**SITE PLAN REVIEW SHEET  
ENVIRONMENTAL VARIANCE REQUEST ONLY**

**CASE:** SP-2015-0328D

**PROJECT NAME:** Bob Johnson Gas Station

TO: Marisa Perales, Chairperson and Members of the Environmental Commission  
FROM: Taylor Horton, Environmental Review Specialist Senior  
Development Services Department  
DATE: July 7, 2016  
SUBJECT: Bob Johnson Gas Station SP-2015-0328D

# BOB JOHNSON GAS STATION SITE PLAN

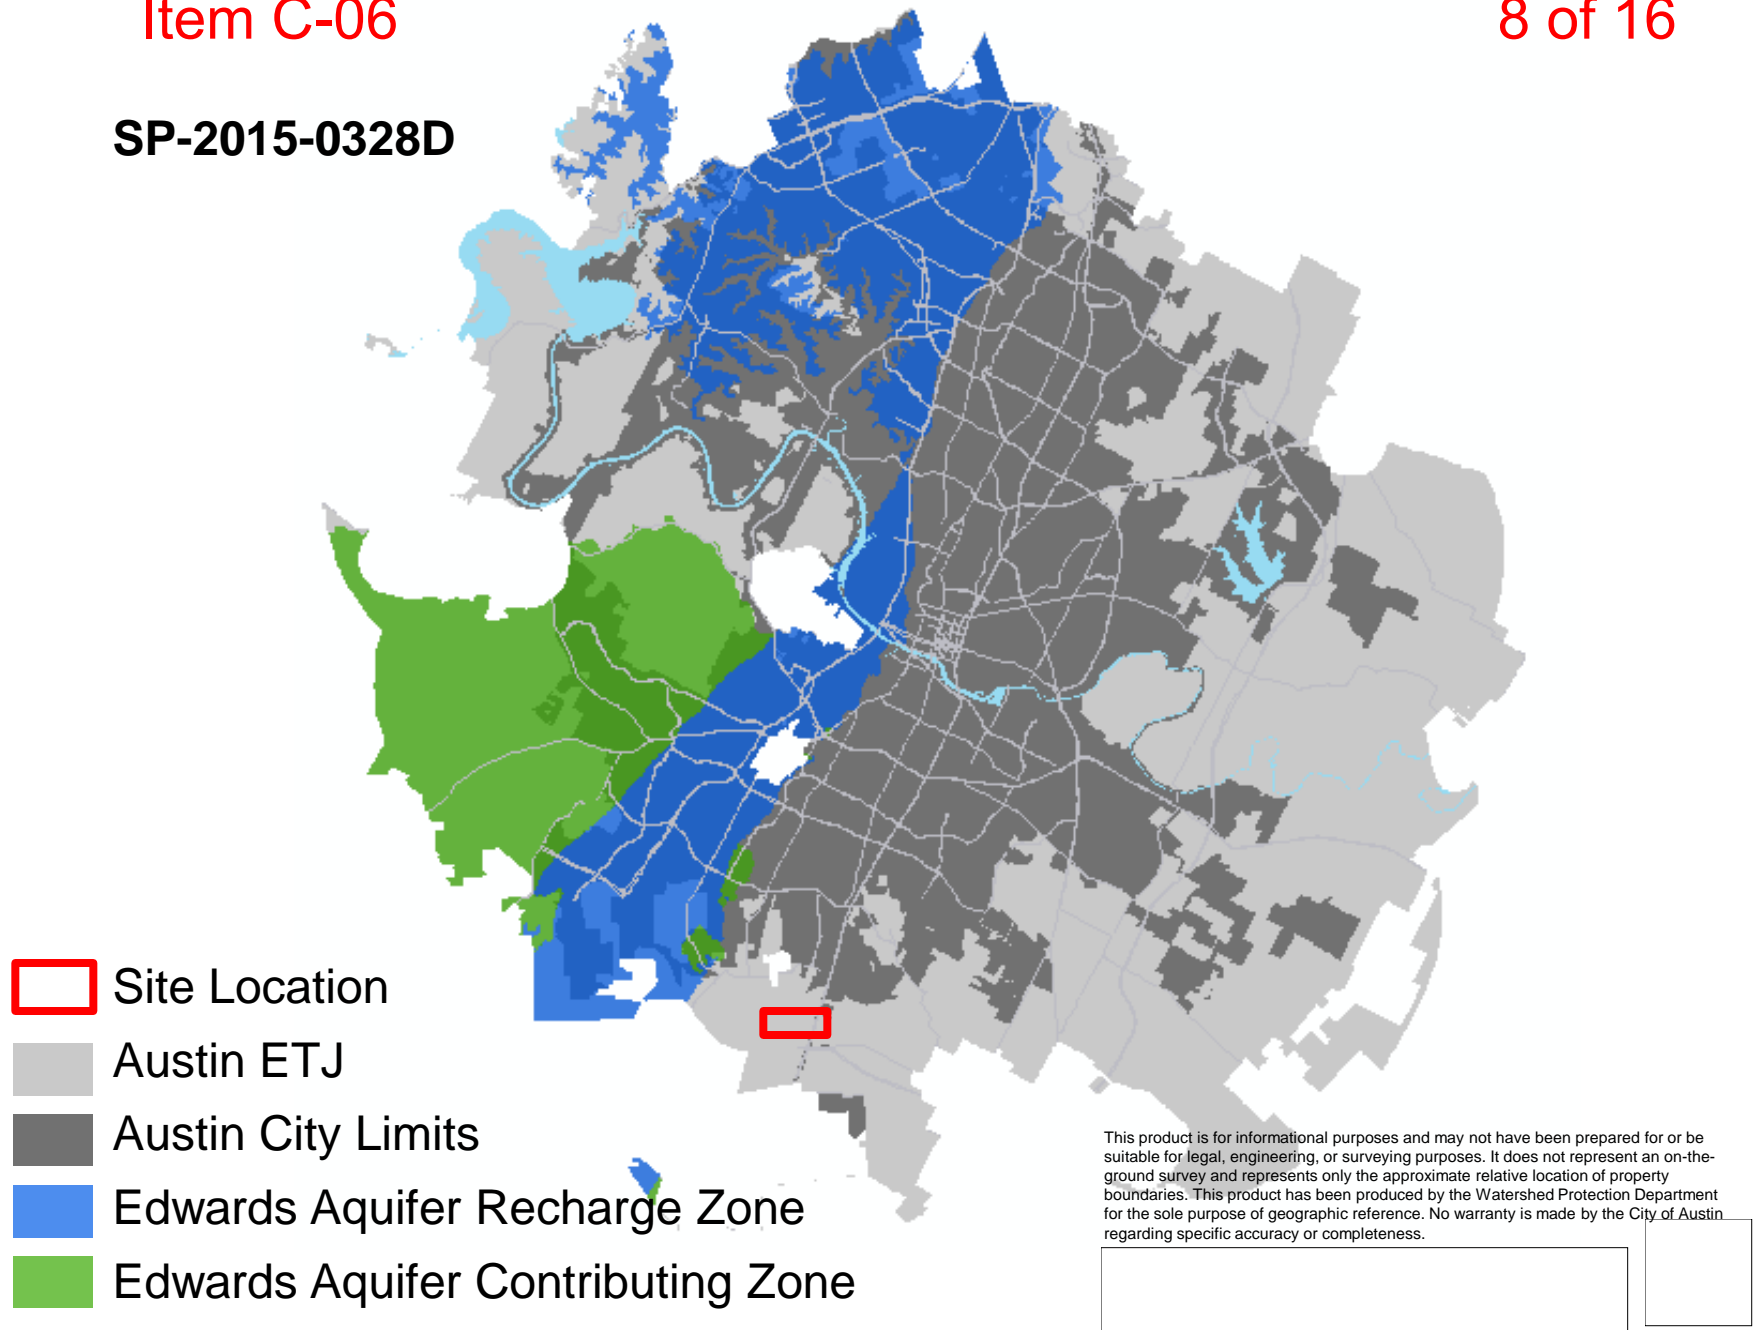
**Second driveway proposed to access gas station/store**

- Alignment crosses slopes over 15%

- Allow construction of driveway on slopes  
> 15%

**Staff does not recommend approval:**

- *Findings of Fact have not been met*
